Amendment No. 92
License No. DPR-57

Amendment No. 30
License No. NPF-5

SAFETY EVALUATION BY THE OFFICE OF NUCLEAR REACTOR REGULATION
SUPPORTING AMENDMENT NO. 92 TO FACILITY OPERATING LICENSE NO. DPR-57
AND AMENDMENT NO. 30 TO FACILITY OPERATING LICENSE NO. NPF-5

EDWIN I. HATCH NUCLEAR PLANT, UNITS NOS. 1 & 2
DOCKETS NOS. 50-321 AND 50-366

WATER LEVEL NOMENCLATURE

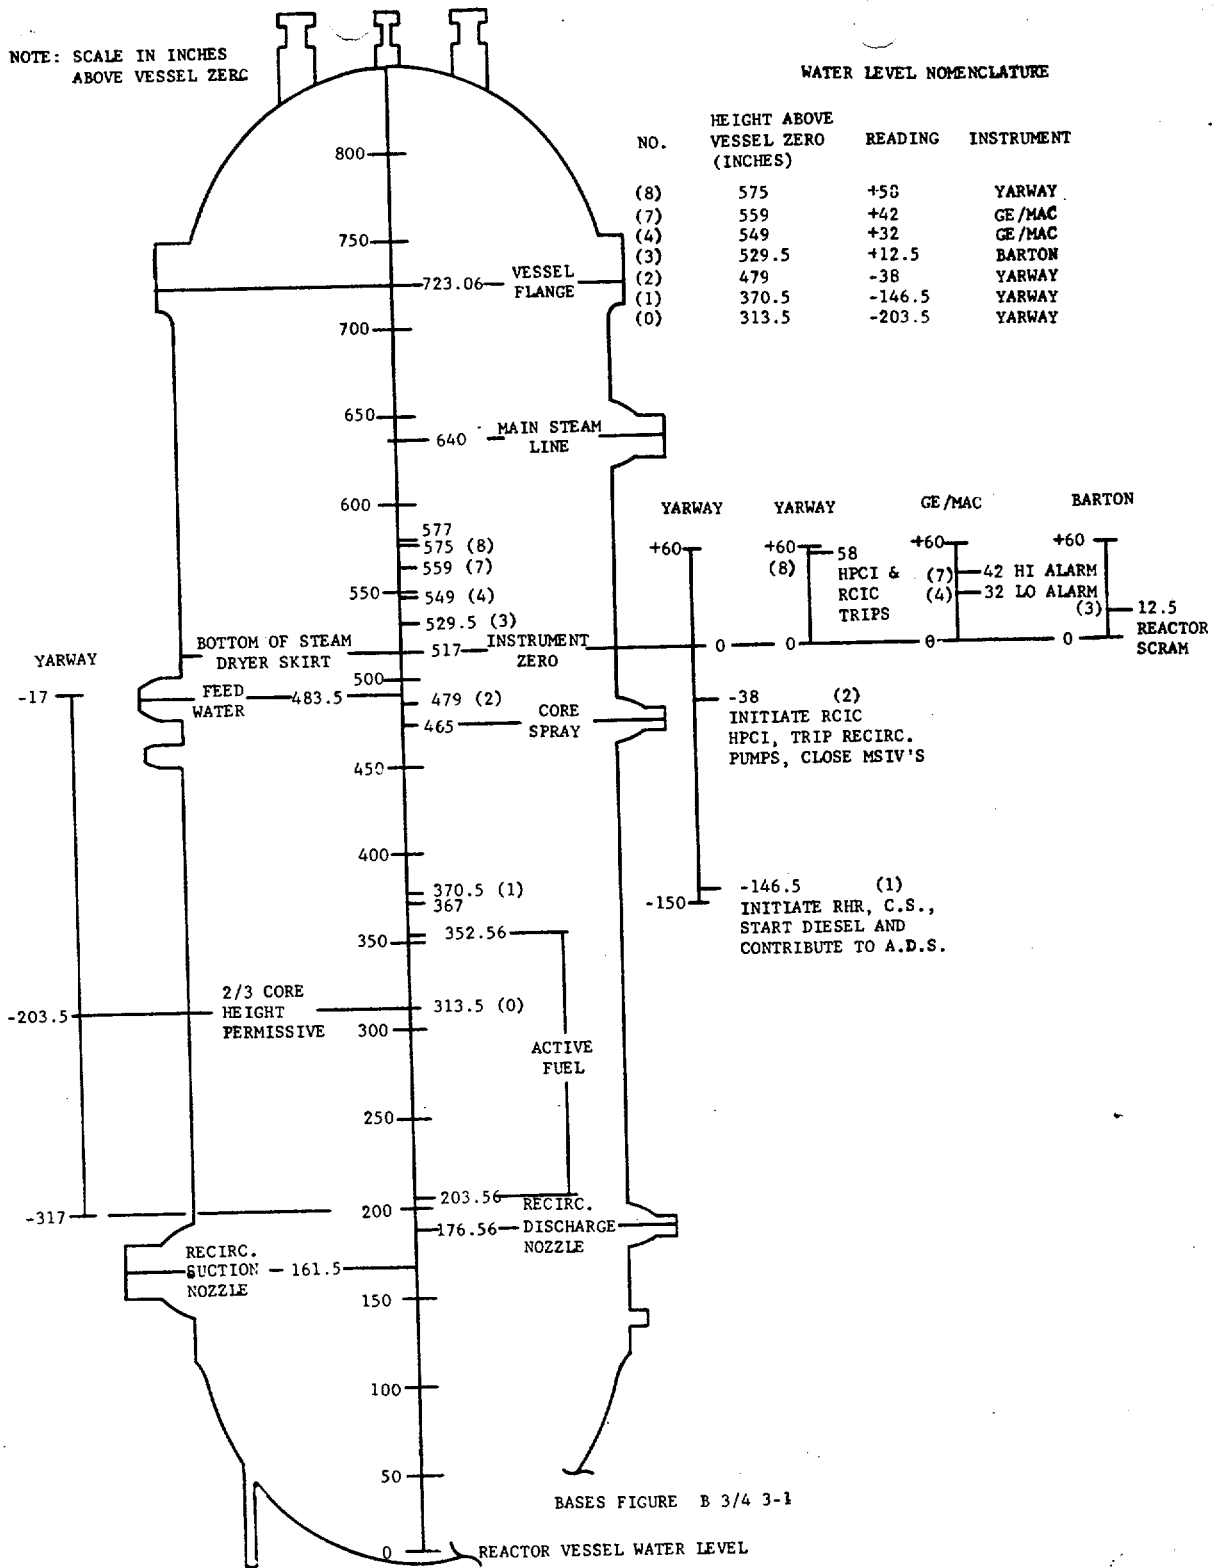
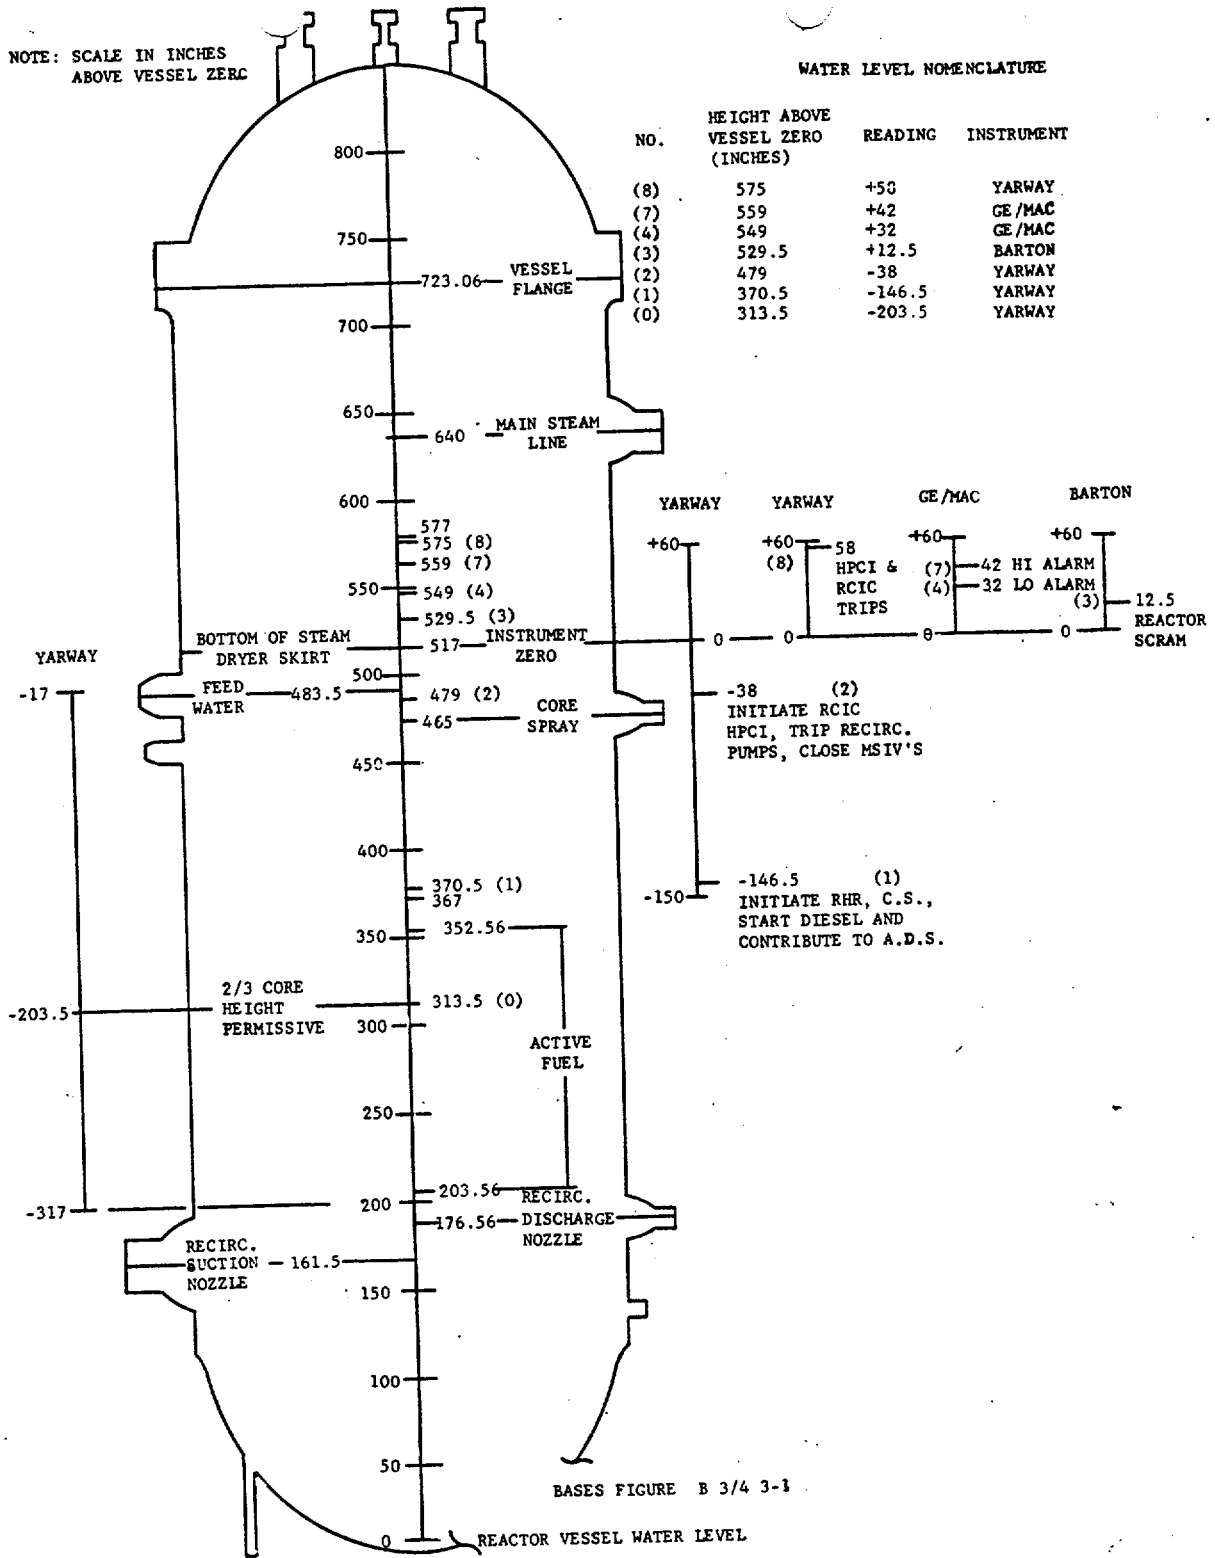
The amendments revise the TSs for both Hatch Unit No. 1 and Unit No. 2 to modify the numerical values of the reactor water levels and the setpoints for reactor water levels measured by the shroud water level instruments to make them consistent with a change in the zero reference level.

By letter dated March 10, 1982, Georgia Power Company (GPC or the licensee) proposed revisions to the Technical Specifications (TSS) for both Hatch Unit No. 1 and Unit No. 2 to change the numerical values of the reactor water levels and the setpoints for reactor water levels measured by the shroud water level instruments to make them consistent with a change in the zero reference level. The change is required in order to make the TSS consistent with previous modification of the reactor water level instruments to utilize a common zero reference level pursuant to NUREG-0737, Item II.K.3.27. In that modification, the zero water level references for the instruments measuring the reactor shroud water level were changed from a level near the bottom head of the reactor vessel to that level near the bottom of the steam drier skirt that is used as the common zero level reference by all of the other reactor water level instruments. The changes to the TSS involve only numerical changes. The actual levels at which protective functions or permissive signals are initiated are unchanged. On the basis of the above discussion, we conclude that the proposed change is acceptable.

*See Bases Figure B 3/4 3-1.
